1987 - 1991 Corvette: Service Bulletin: 4L60 Low & Reverse Clutch New Plate Available

Subject: 4L60 LOW & REVERSE CLUTCH NEW WAVE PLATE IS AVAILABLE

Bulletin Number: 91-186-7A - (01/29/1991)

Figure 1 - HYDRA-MATIC 4L60 Transmission Identification Information

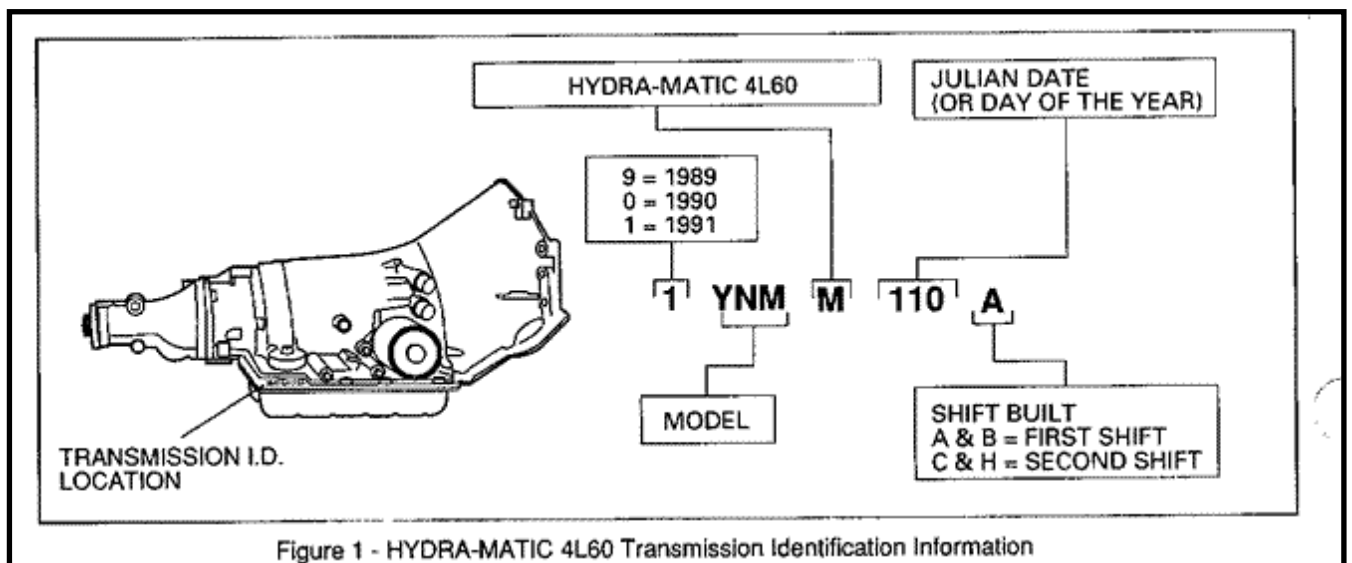
DATE OF PRODUCTION CHANGE: (Figure 1)

----- Beginning March 28,1990 (Julian Date 087), all HYDRA-MATIC 4L60 transmissions were built using the new low and reverse clutch wave plate.

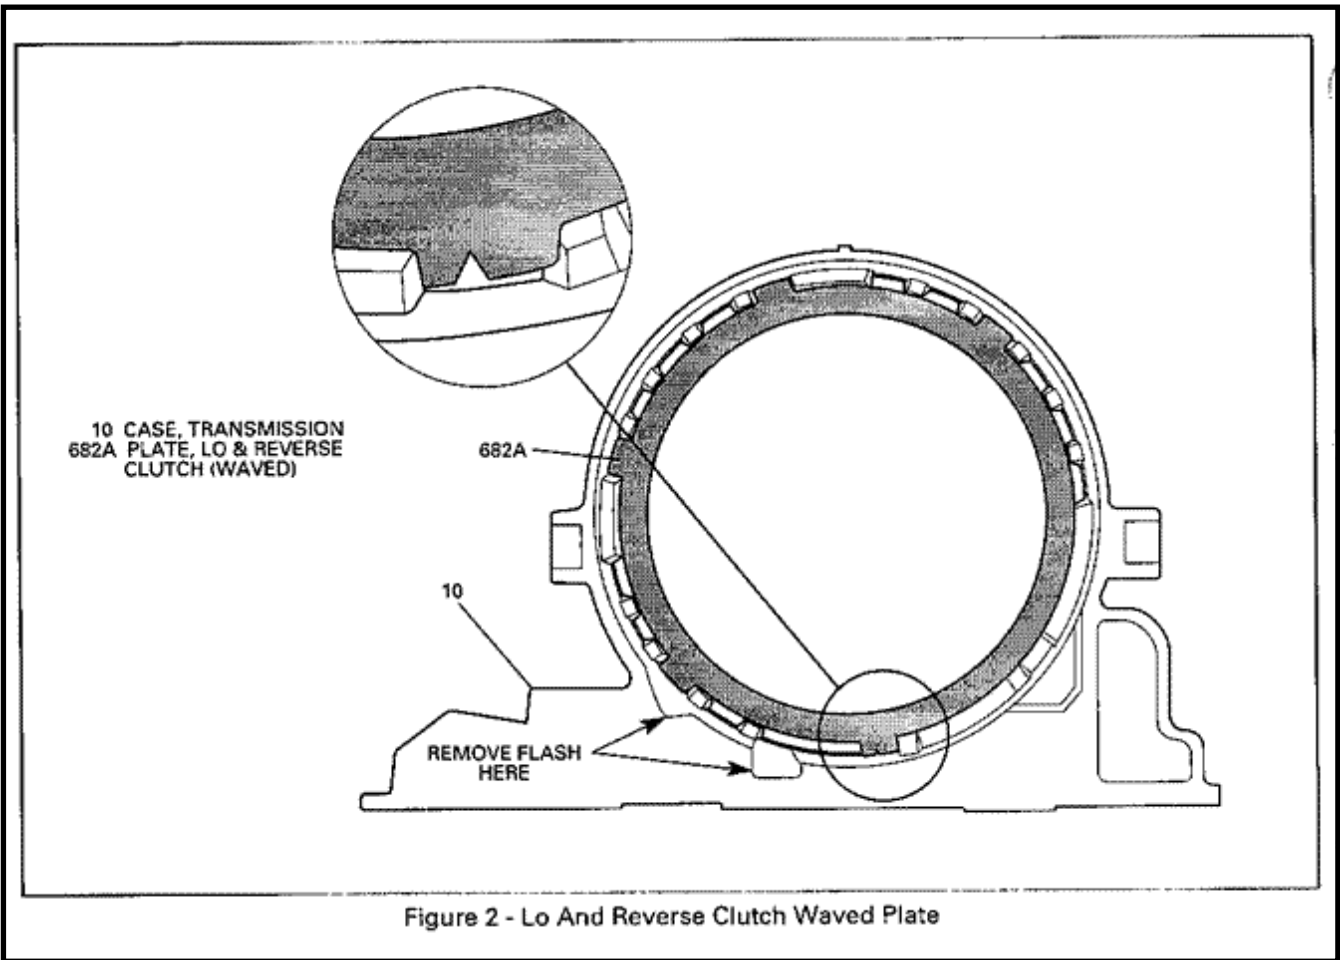
SERVICE INFORMATION: (Figure 2) ----- Low and Reverse Clutch failure can be caused by case casting flash interfering with clutch plate travel. A new wave plate is now available which will alleviate this condition. This new plate can be used to service any Hydra-matic 4L60 transmission produced after February 9, 1987 (Julian Date 040).

When installing the new wave plate, check for any case flash that may be present in the low and reverse grooves, and use a metal file to remove. See Figure 2 for case location information.
